26 January 2017

SUBJECT: Addendum Number 1
Rowan/Kannapolis ABC Store and Warehouse
Salisbury, NC

FROM: Ramsay, Burgin, Smith Architects, Inc.
225 North Main Street, Suite 501
Salisbury, NC 28144

SHEET NO.
SBD |

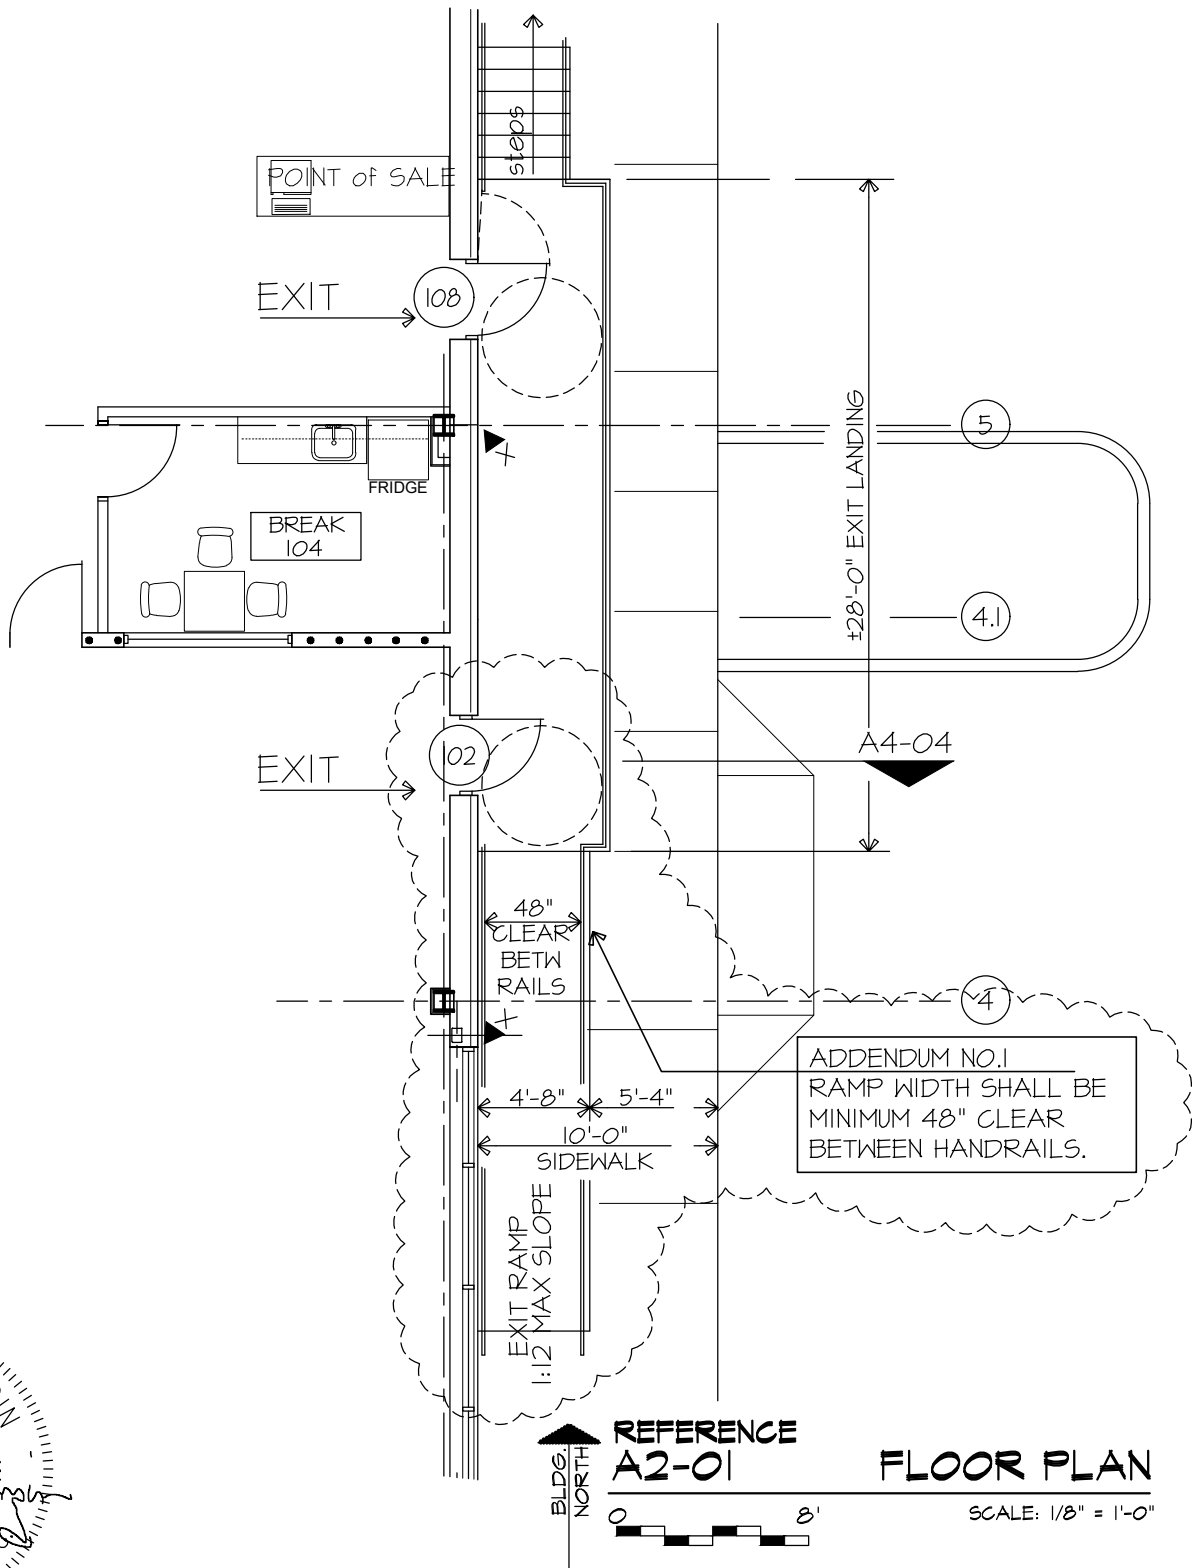
- Item 13- Reference A4-03 Wall Section. Revise all references (including those on A1 Site Plan Notes) to Aluminum Downspouts to Size 4x4.
- Item 14- Reference A5-02 Wall Sections – Canopy. Revise Canopy Signage Tube Steel Supports to include (6) 2x2 tubes (two tubes per letter) as indicated on Structural Bulletin SBD1.

- Item 1- See Attached **Bulletin SBD1** – Reference 1/S1.20 Framing Plan and Detail 10/S1.20 Section Through Entry Canopy. Revise Canopy Signage Steel. Provide (6) HSS 2x2x 5/16 Cuffs extending 20 inches above canopy deck. There shall be two cuffs per letter – A B C – for the signage company to sleeve / mount their signage onto/over.

ABI

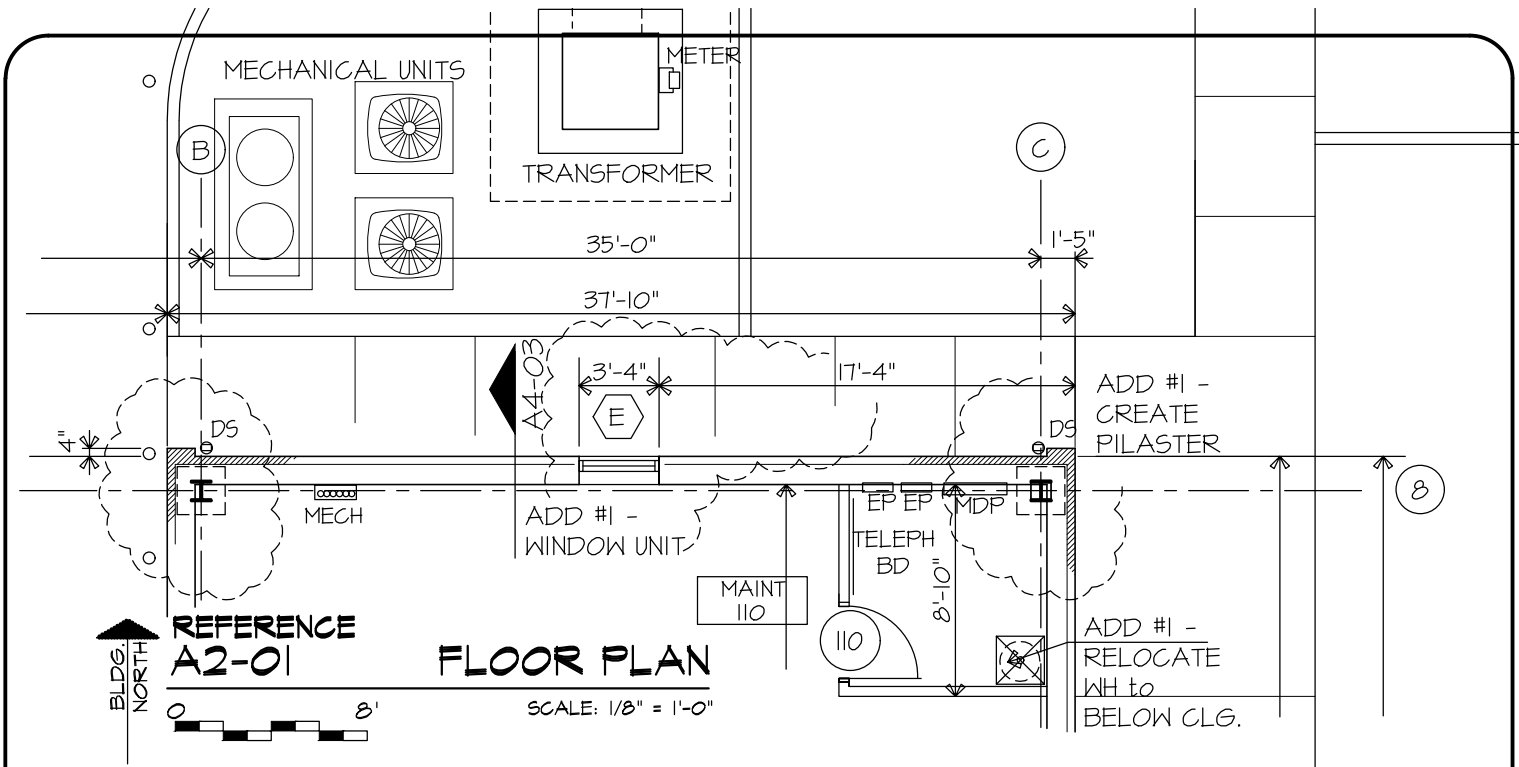
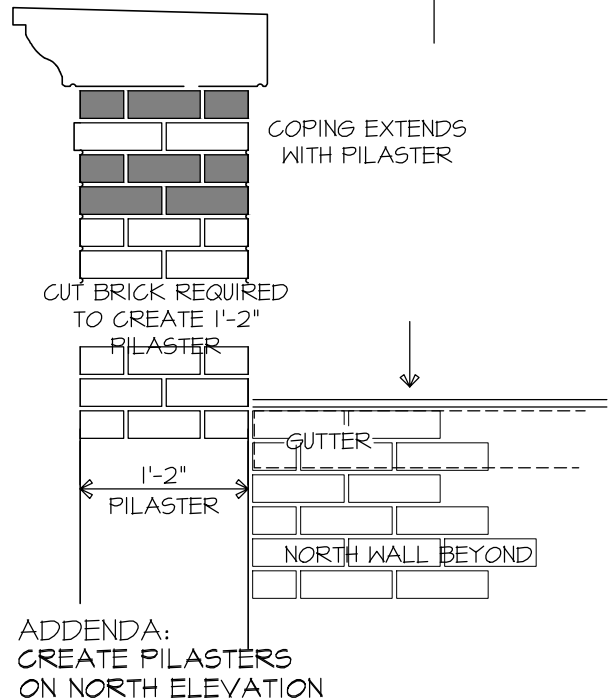
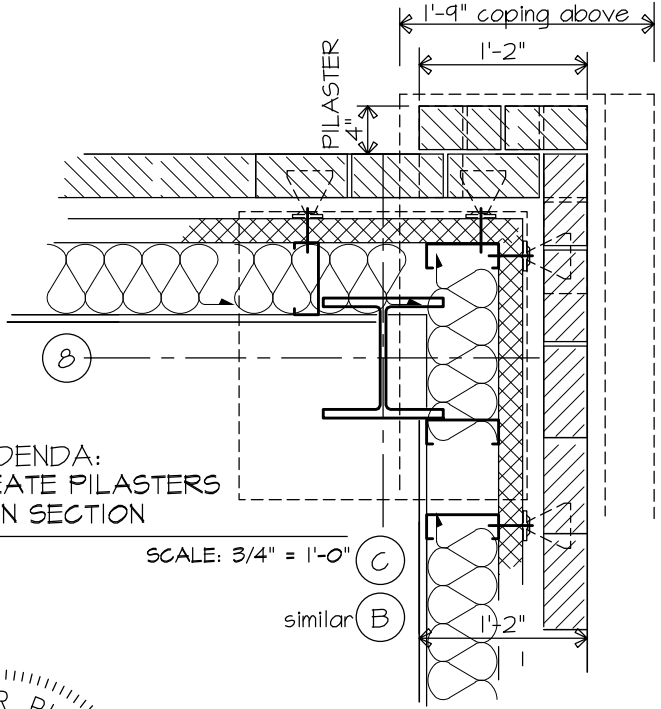
- Item 7- See attached **Bulletin AB01.** Reference A2 Floor Plan. For clarification, the Exit Ramp shall be minimum 48 inches clear between handrails.

SHEET NO.
AB2
OF

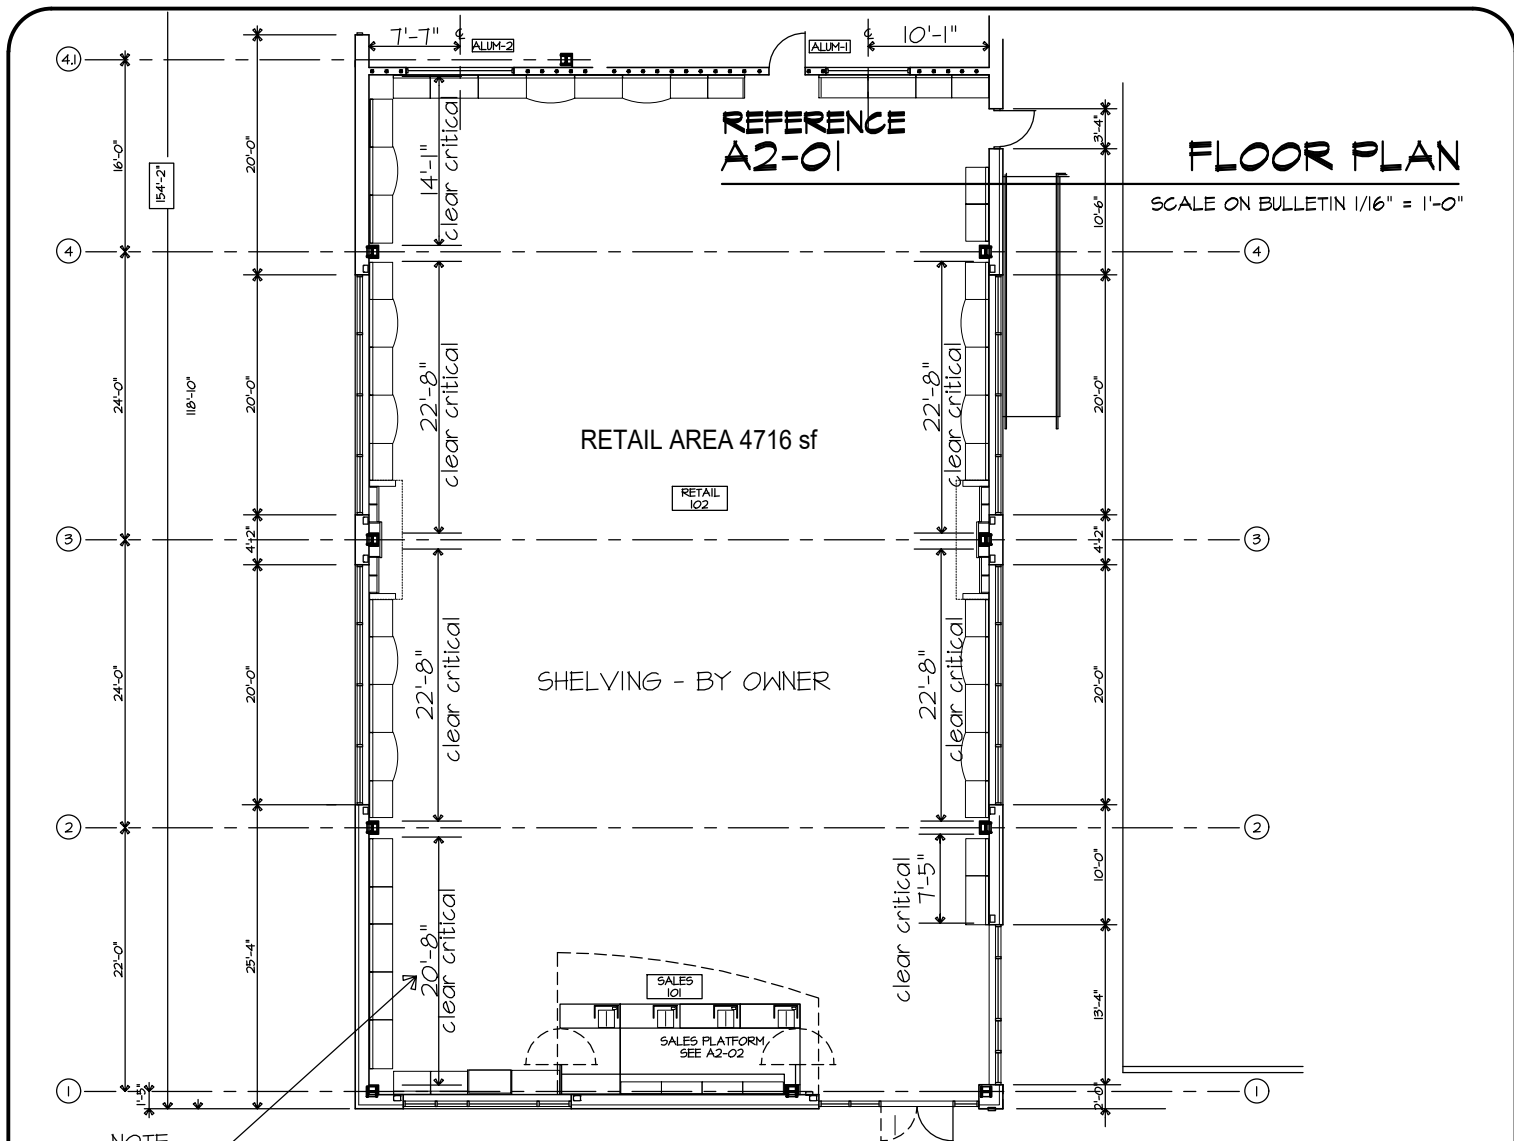
- Item 8- See attached **Bulletin AB02.** Reference A2 Floor Plan.
Create Pilasters on North Wall as indicated.
Add Aluminum Storefront Window Unit "E" to North Wall as indicated.
Relocate Water Heater in Maintenance Room 110 to mount on wall below suspended acoustical ceiling. (See Plumbing Addenda Items)

Note: PILASTER TO EXTEND TO FOOTING. TRANSITION TO 4" CMU BELOW GRADE

DECORATIVE CORNICE
SEE BULLETIN AB4

SHEET NO.
AB3

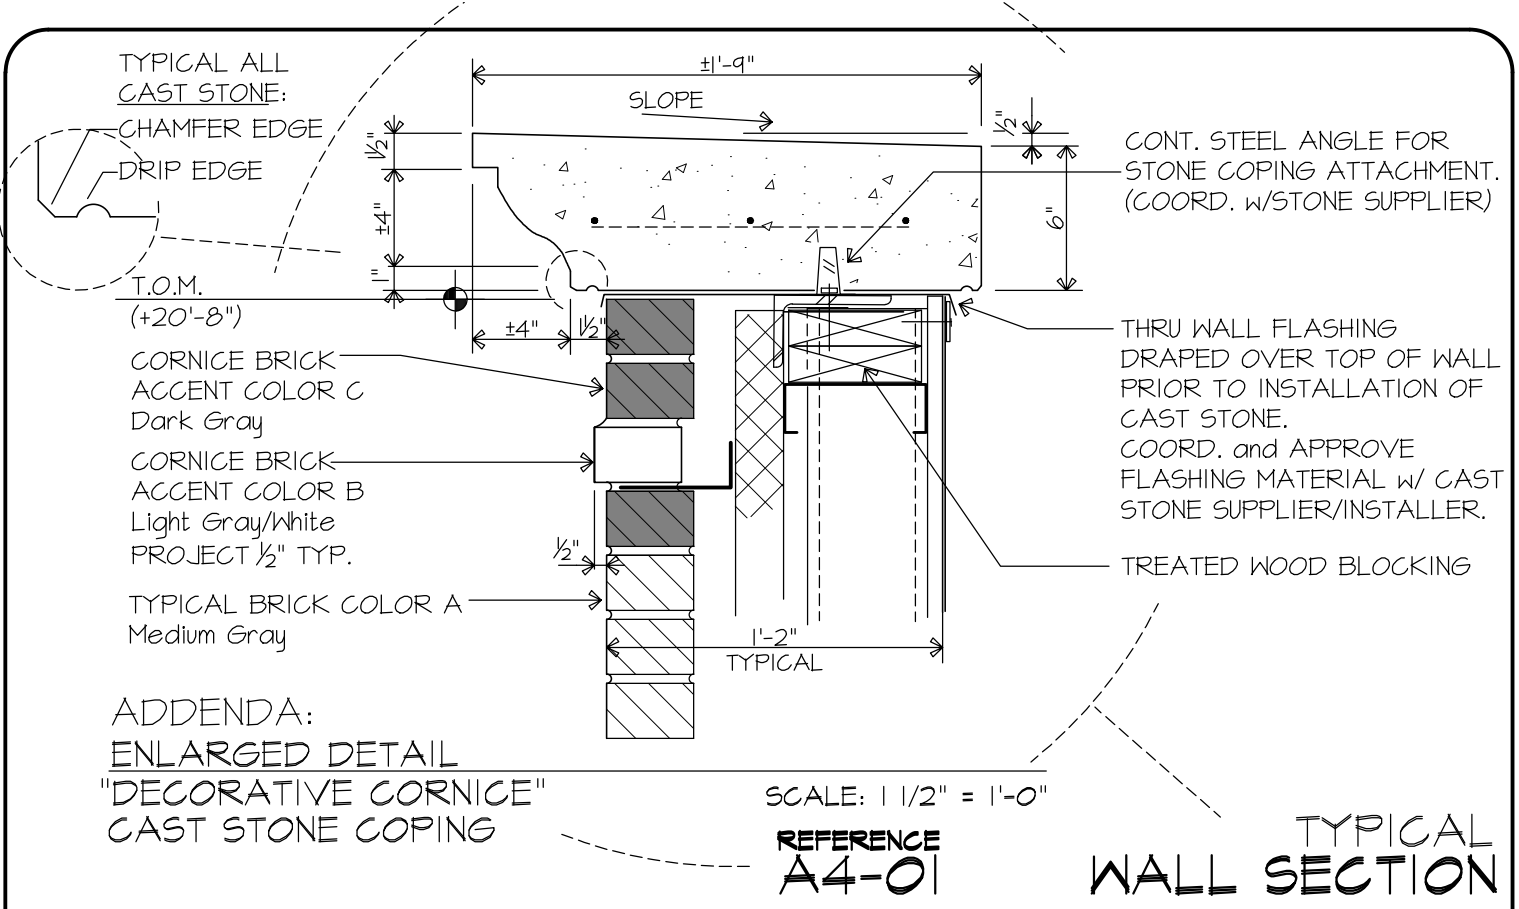
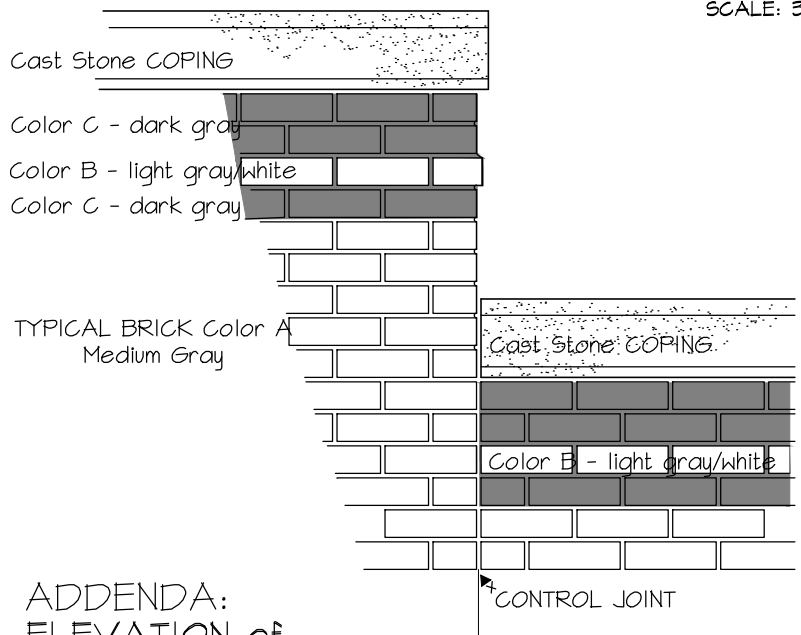
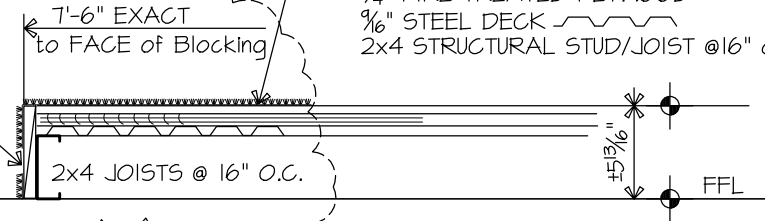
- Item 9- See Attached **Bulletin AB03.** Reference A2 Floor Plan.
Partial Floor Plan (reduced scale to 1/16") shown to clarify Critical Dimensions. Critical Clear Dimensions shown on plans are just that – critical. These dimensions are critical to the Owner's Shelving Installation.
Revise A2-03 Platform Detail – Revised detail to include treated solid wood blocking at all edge conditions. Owner will provide and install carpet "wrapped" edge – carpet to extend to floor level.

THE CLEAR CRITICAL DIMENSIONS SHOWN HERE ARE MINIMUM CLEARANCES BETWEEN THE FINISHED WRAPPED COLUMNS and/or THE WRAPPED COLUMNS & WALLS or WINDOW JAMBS. THESE ARE CRITICAL TO THE OWNER'S SHELVING/DISPLAY INSTALLATION.

ADDENDA:
REVISE EDGE CONDITION
OF PLATFORM

SHEET NO.
AB4
OF

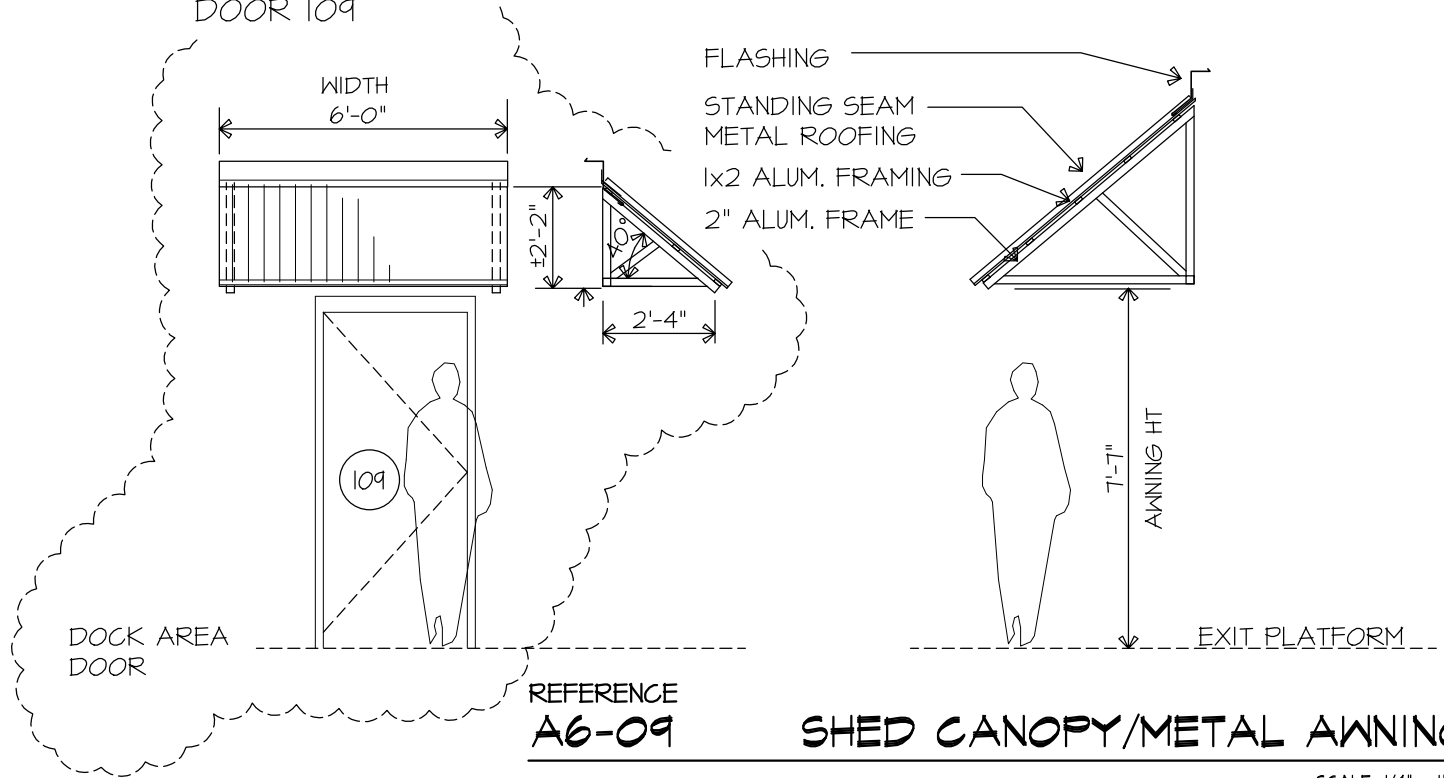
- Item 12- See Attached **Bulletin AB04.** Reference A4-01 Wall Section. Revise Cast Stone Coping Enlarged Detail to include the **Decorative Cornice** as indicated on the Bulletin. The Decorative Cornice shall include a larger "ogee profile" Cast Stone Coping as well as the Four Brick Courses below the Cast Stone Coping. One projected Brick Course (+1/2") in Accent Color B and the other Three Brick Courses in Accent Color C. The Decorative Cornice shall be provided on all three elevations – South, East and West and shall be stepped as indicated on drawings.

AB5

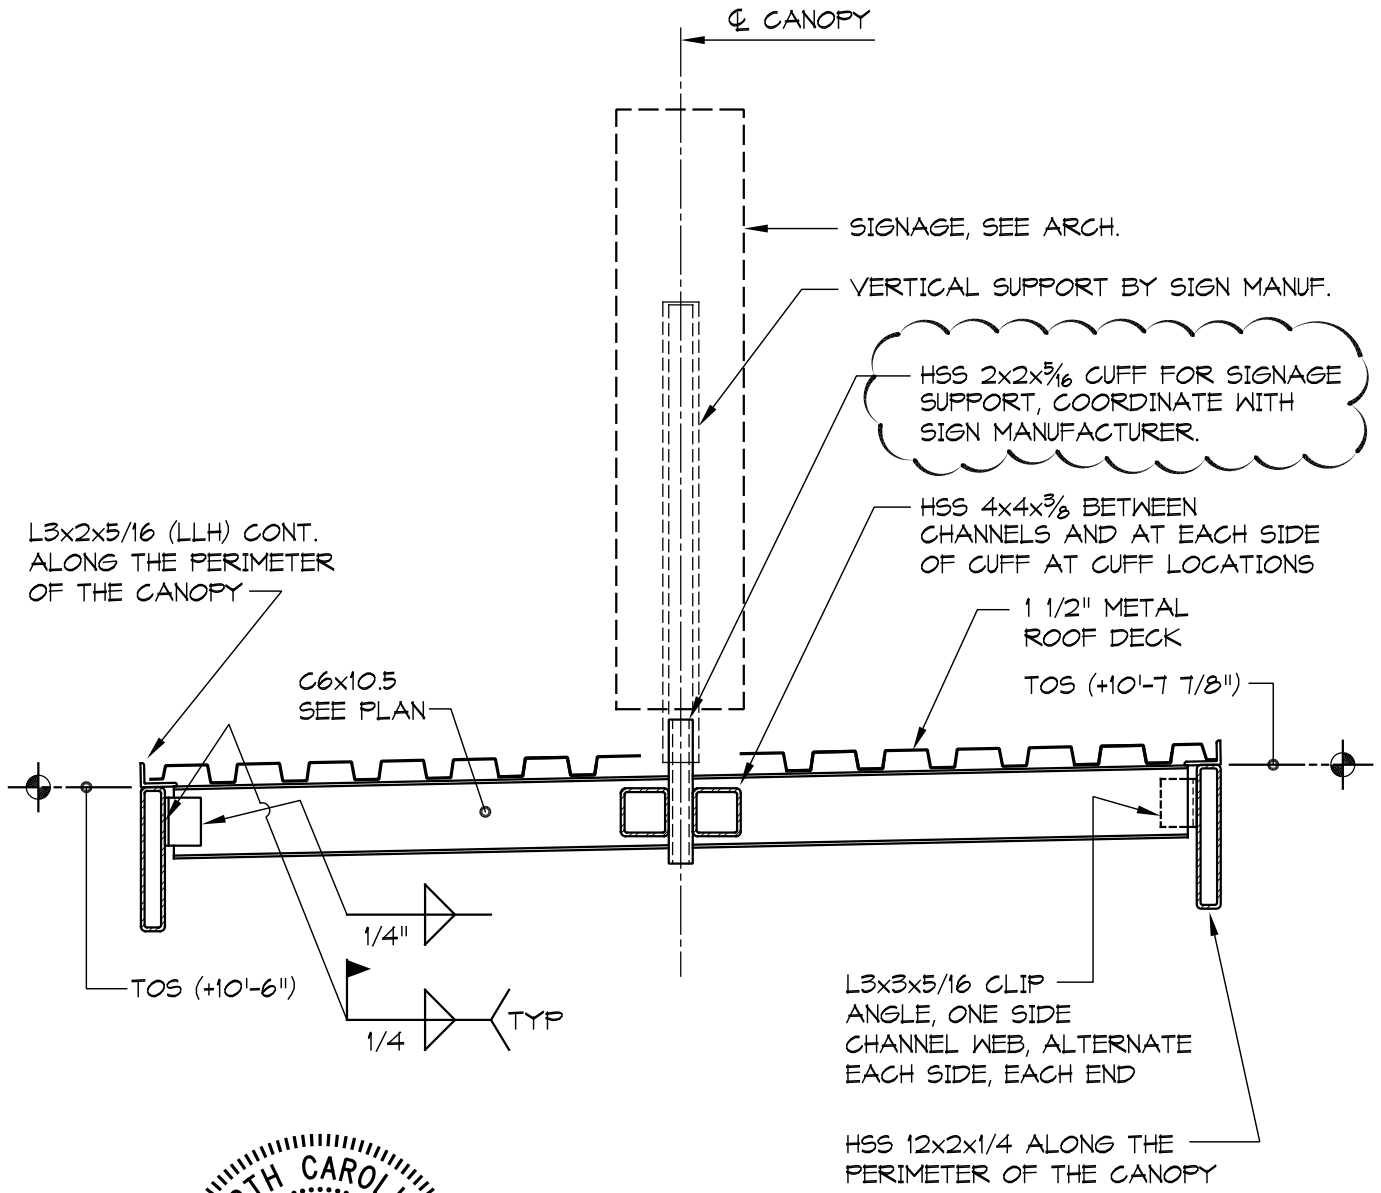
Item 15- See Attached **Bulletin AB05**. Reference A6-09 Shed Canopy/Metal Awnings. Add 6'-0" Canopy over Door 109 as indicated.

ADDENDA
ADD CANOPY OVER
DOOR 109
